Ventura County Community College District

DATE: May 15, 2025
TO: All Bidders
FROM: Spencer Herson, Purchasing Specialist
SUBJECT: Addendum 1 – Bid 709, Ventura College Stem Program Building Improvements

Drawings: Changes and clarifications noted as Addendum 01 and dated 05/15/25

CONCRETE BENCH

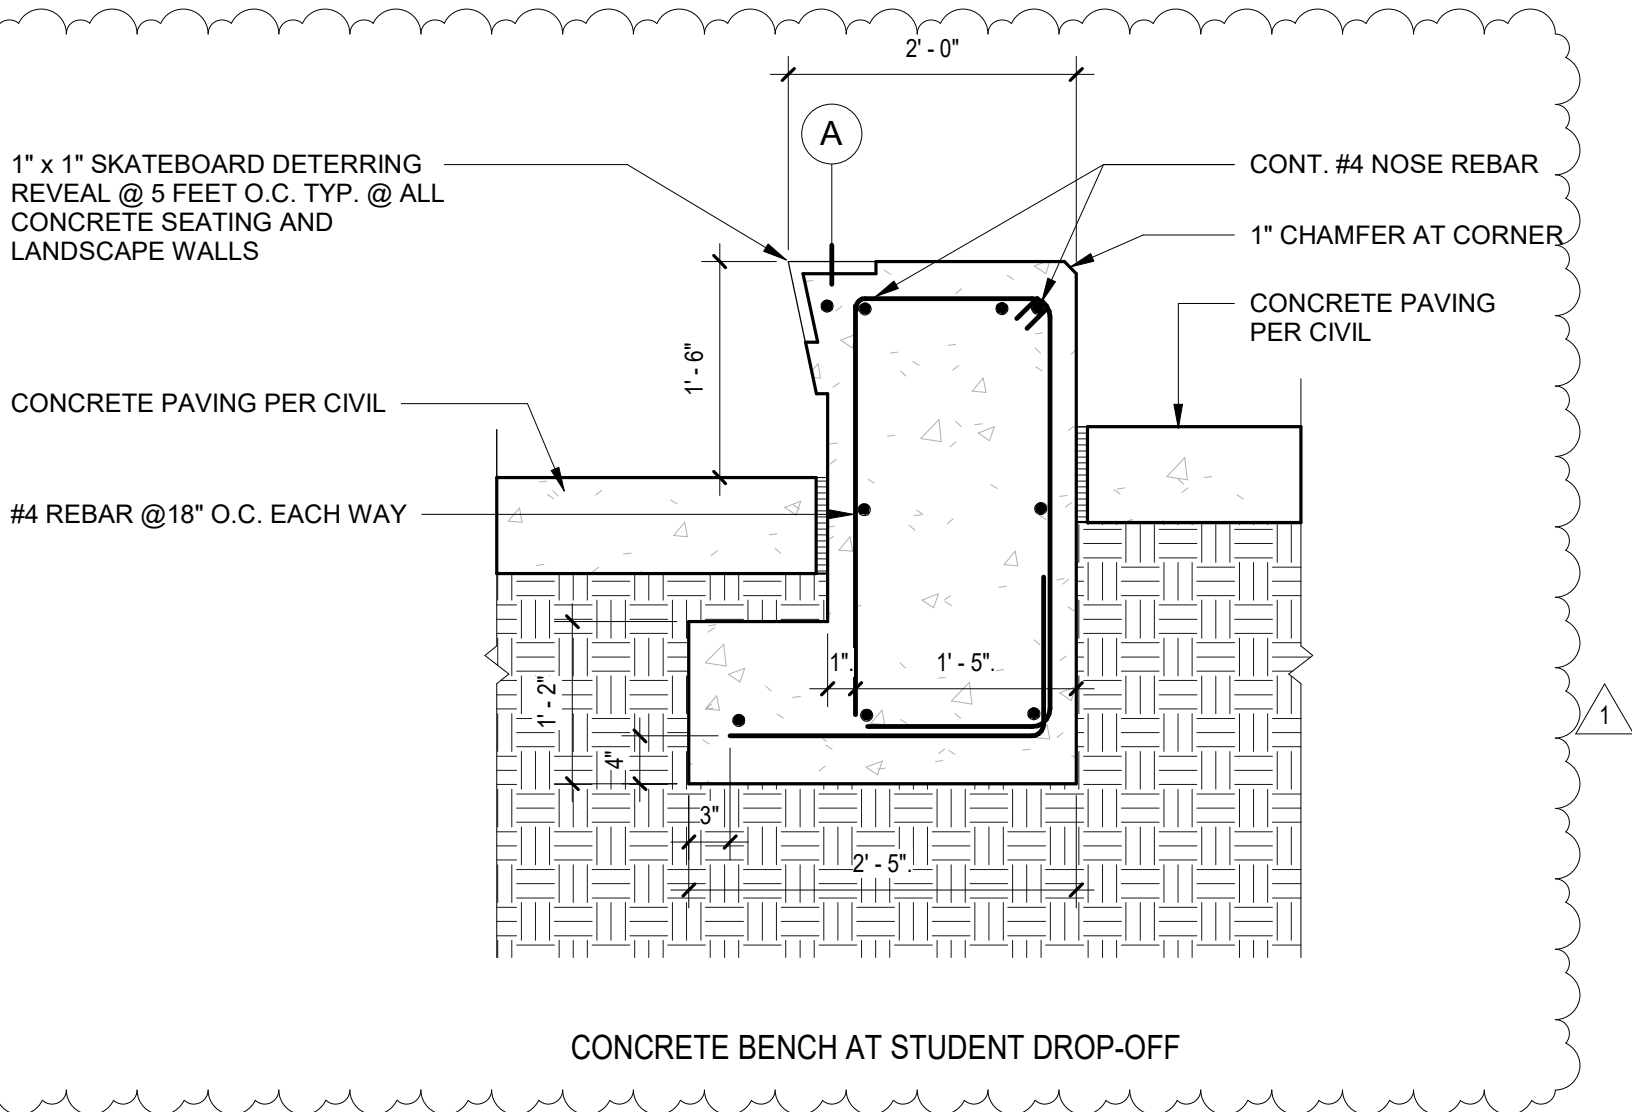
A501 – DETAIL 7/A501, CONCRETE BENCH AT STUDENT DROP-OFF ADDED.

SOUTH ELEVATION SITE

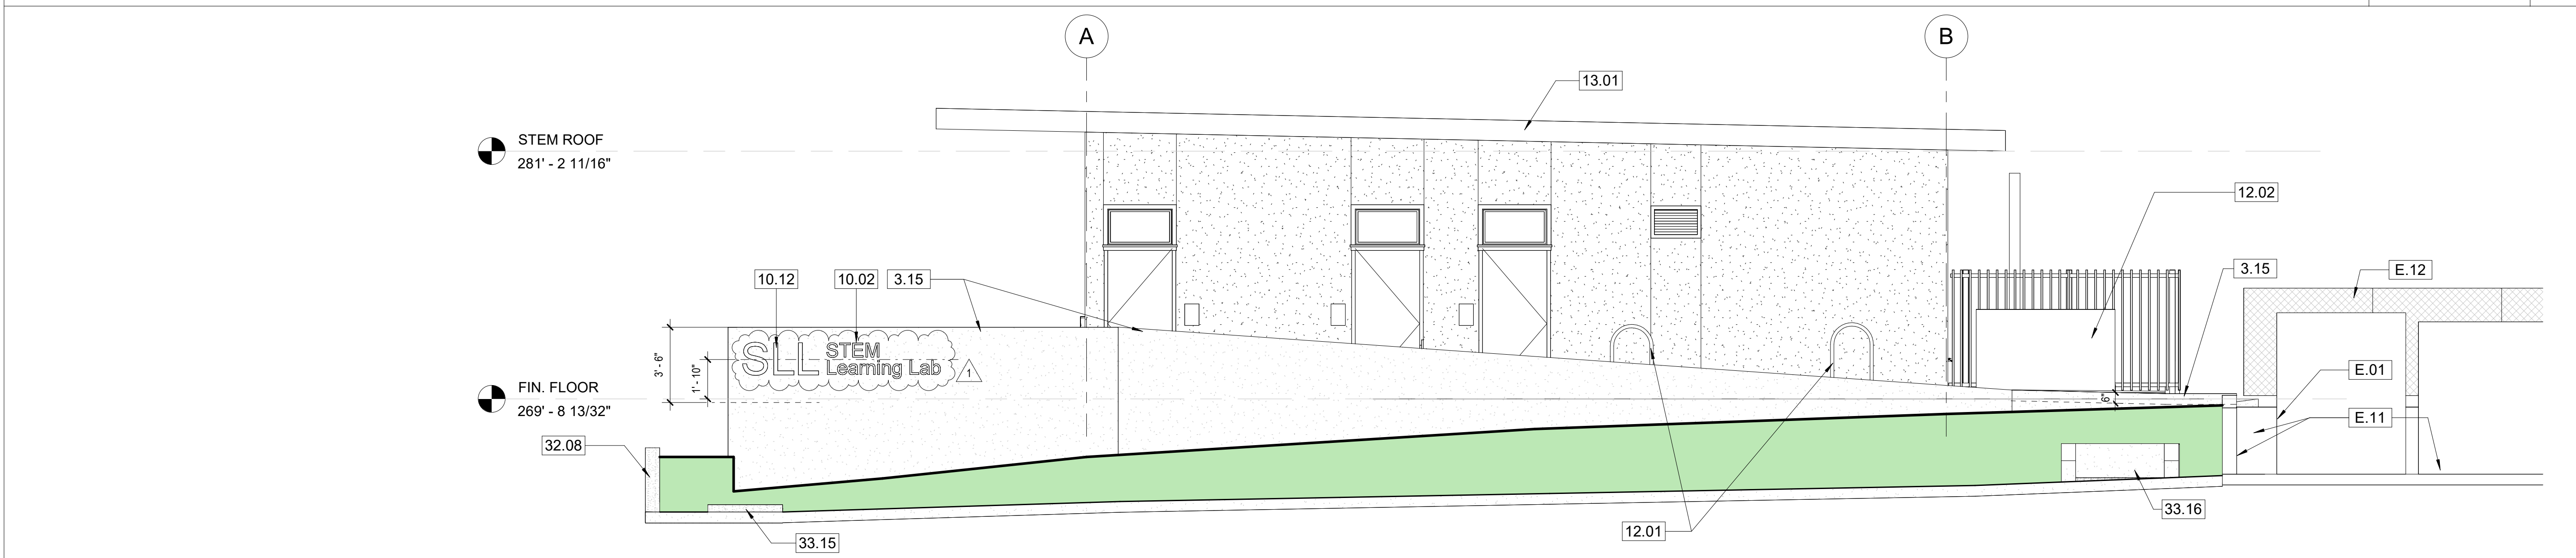
A202 – SITE EXTERIOR ELEVATIONS; 3/A202 SOUTH ELEVATION SITE, KN 10.02 BUILDING SIGN REVISED

TYPICAL SECTION AT CONCRETE RAMP & LANDING ON GRADE

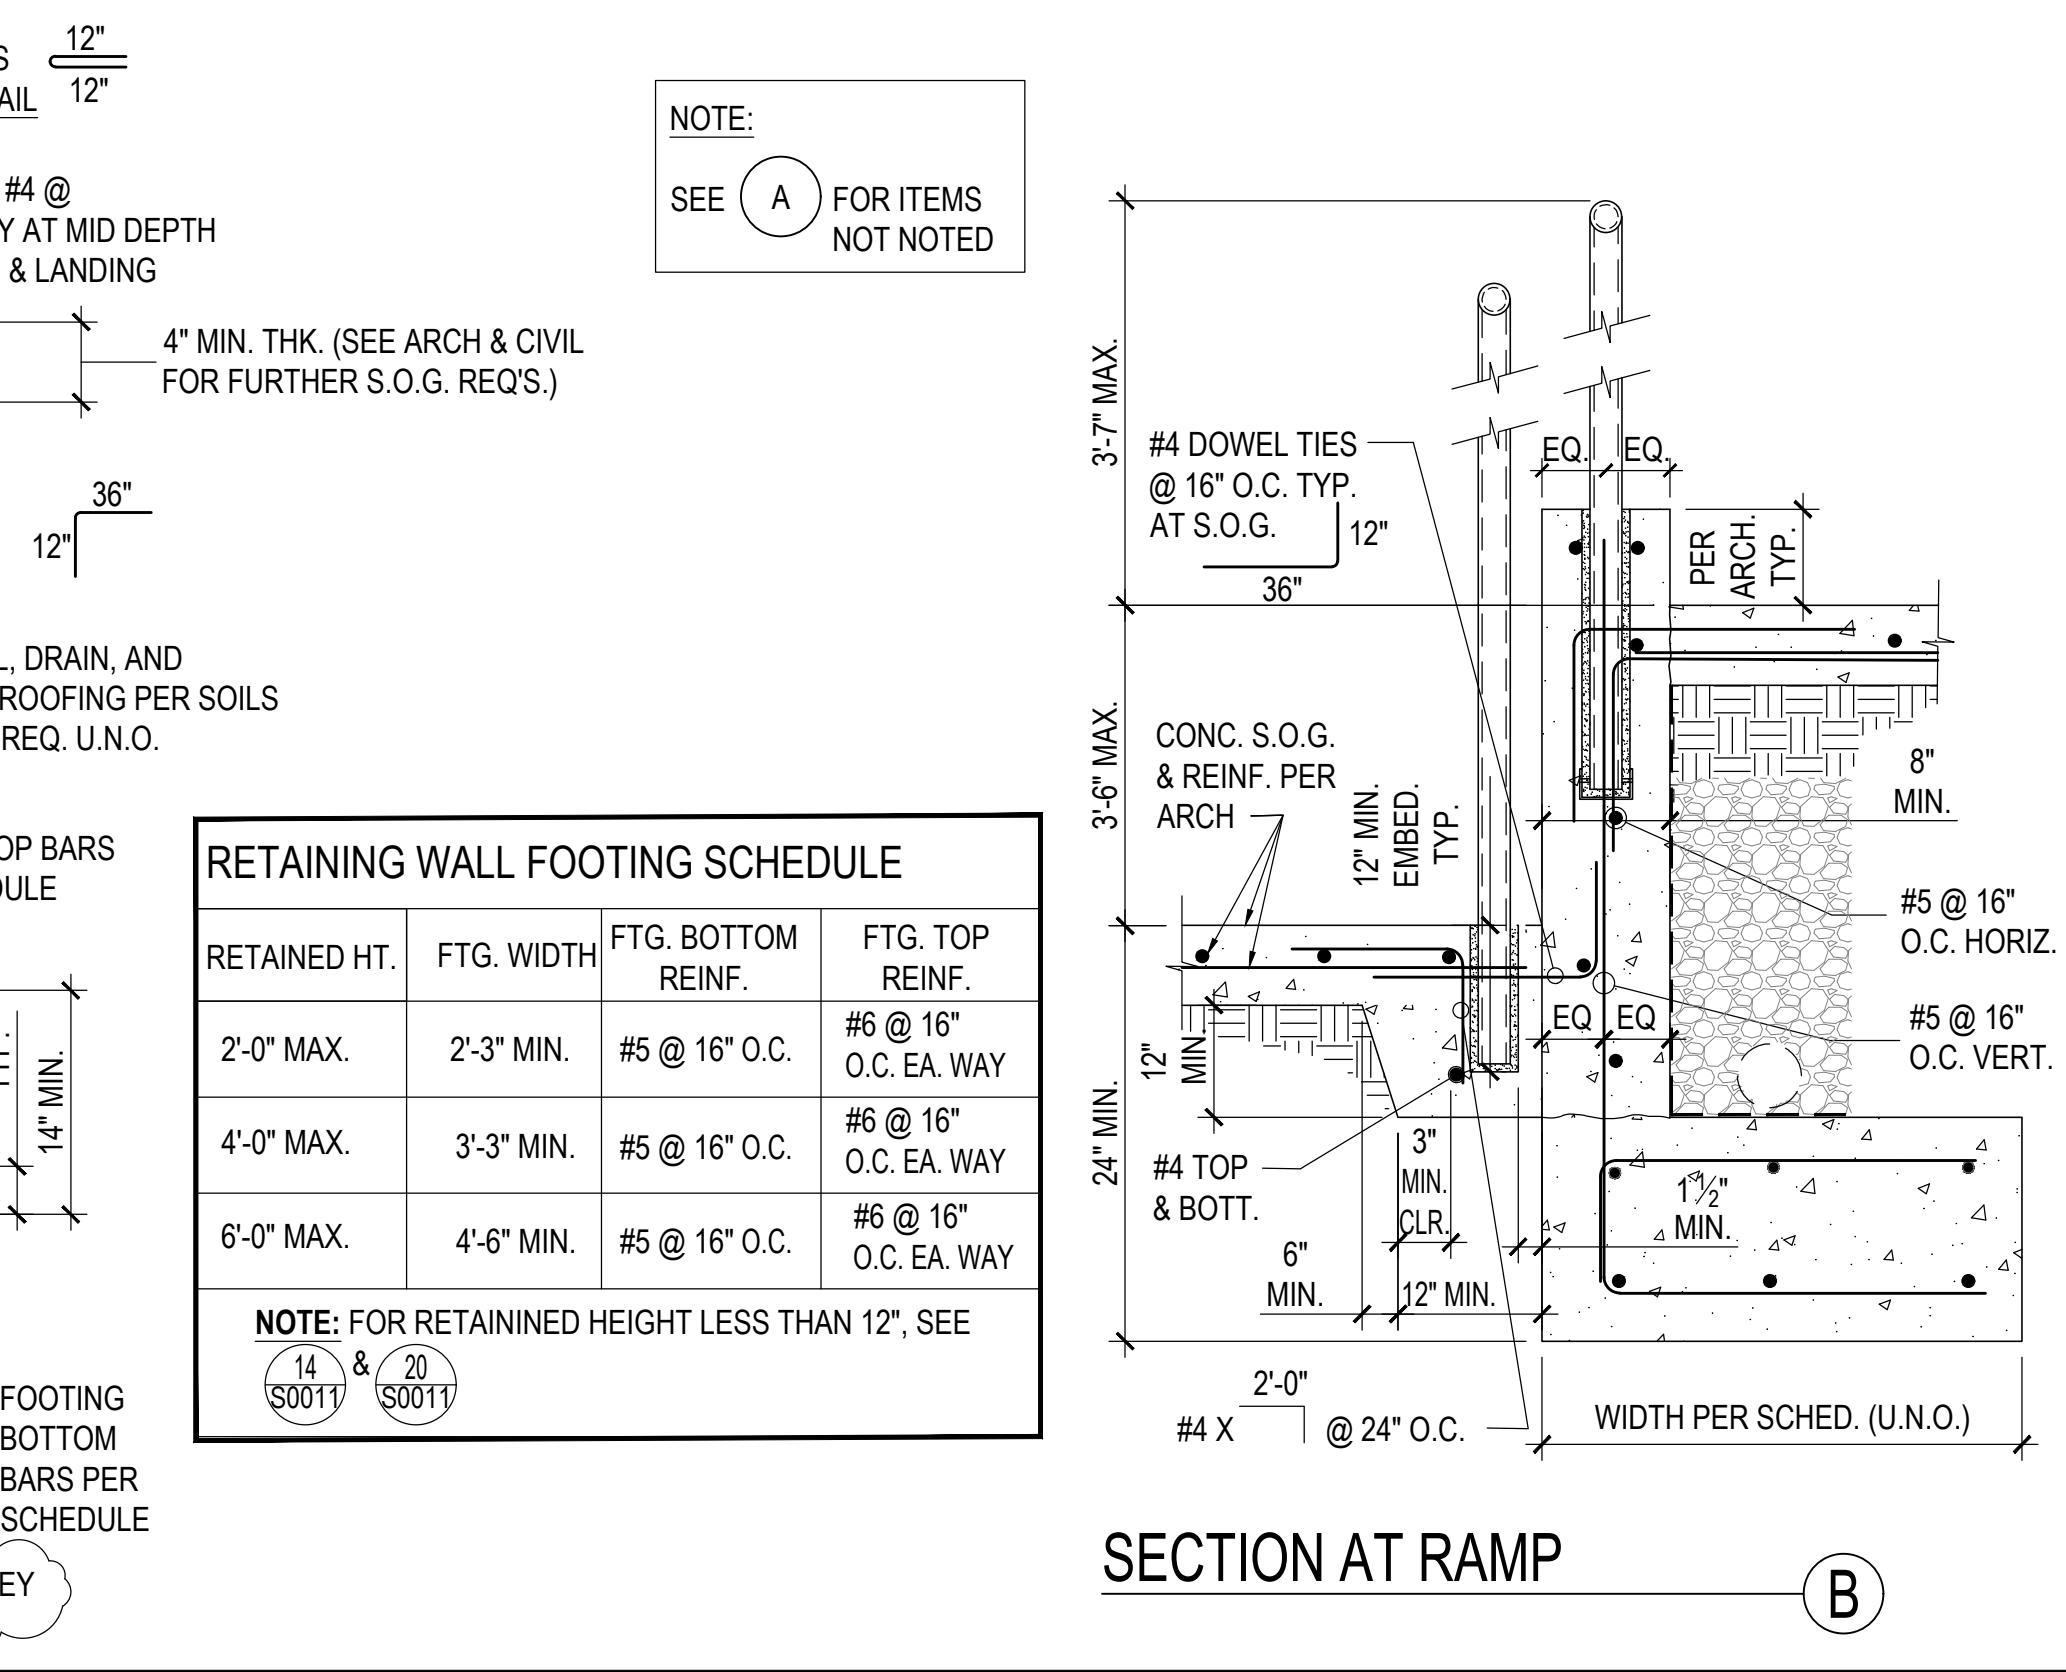
S012 – TYPICAL DETAILS: DETAIL 33/S012 SECTION AT RAMP LANDING EDGE KEY ADDED.
